**ENVIRONMENTAL PROTECTION AGENCY**

**Approval and Promulgation of Air Quality Implementation Plans; Wyoming; Revisions to Regional Haze State Implementation Plan; Revisions to Regional Haze Federal Implementation Plan**

**ACTION:** Final rule.

**Figure 1. Map Depicting Federal Class I Areas and Representative IMPROVE Monitors in Wyoming.**

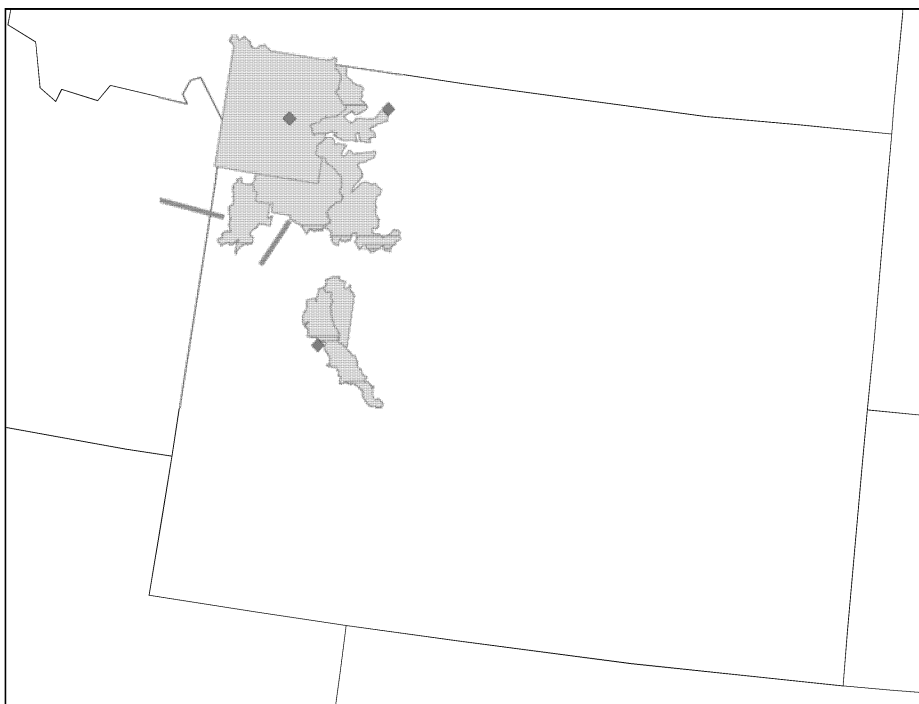
*Comment:* Finally, the commenters argue that multiple features of the EPA’s modeling exacerbate the uncertainty inherent in CAMx and compound the unreliability of the results on which the EPA relies upon in its BART alternative determination, including:<sup>98</sup>

*Response:* We disagree with the commenters’ arguments that multiple features of our modeling, including large transport distances, lack of IMPROVE monitors, and the use of PSAT exacerbated the uncertainty inherent in CAMx and compounded the unreliability of the results on which we relied upon in our BART alternative determination. In fact, we utilized multiple tools, as discussed previously, to further evaluate the modeling results to determine whether the results represent “real” modeled visibility differences.

Specifically, it is true that in some geographic areas, single IMPROVE monitors represent multiple Class I areas, based on expected similarities between the airsheds (Figure 1). This
